16074A CALIBRATION R-L STANDARD

MANUAL CHANGES

HP 16074A
Calibration R-L Standard

Model Number: HP 16074A
Date Printed: May 1986
Part Number: 16074-90000

Figure 1. Quasi-Inductance Standard Structure

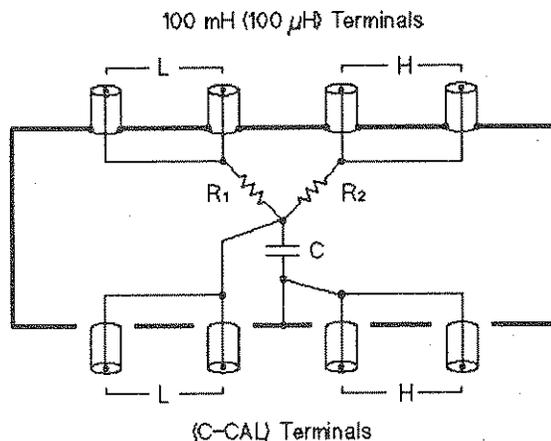
Page 1, Section 5 Quasi-Inductance Standards

Change section 5 as follows:

The HP 16074A's quasi-inductance standard consists of two resistors and a capacitor, and it acts as an inductor when it is measured with HP four-terminal pair LCR meters. Figure 1 shows the quasi-inductance standard's structure and an equivalent impedance when the quasi-inductance Standard's 100 μH (or 100 mH) terminals are connected to an HP LCR meter.

$$Z = R_s + j\omega L_s$$

$$R_s : R_1 + R_2$$

$$L_s : CR_1R_2$$

The quasi-inductance standard's equivalent inductance should be measured by its user before it is used to confirm LCR meter's inductance measurement operation. The measurement procedure is as follows:

1. Measure the two resistors of the quasi-inductance standard using a four terminal connection DC resistance meter, and record these two resistance values as R1 and R2.
 - * R1 is the resistance between the 100 mH (or 100 μ H) L terminal and the (C-CAL) L terminal.
 - * R2 is the resistance between the 100 mH (or 100 μ H) H terminal and the (C-CAL) L terminal.
2. Measure the capacitance of the quasi-inductance standard using a four-terminal pair LCR meter, and record the capacitance value as C.

3. Calculate the equivalent inductance according to the following equation.

$$\text{Equivalent Inductance} = (C - 7 \text{ pF}) \times R1 \times R2$$

* 7 pF is the correction capacitance for the BNC connectors.
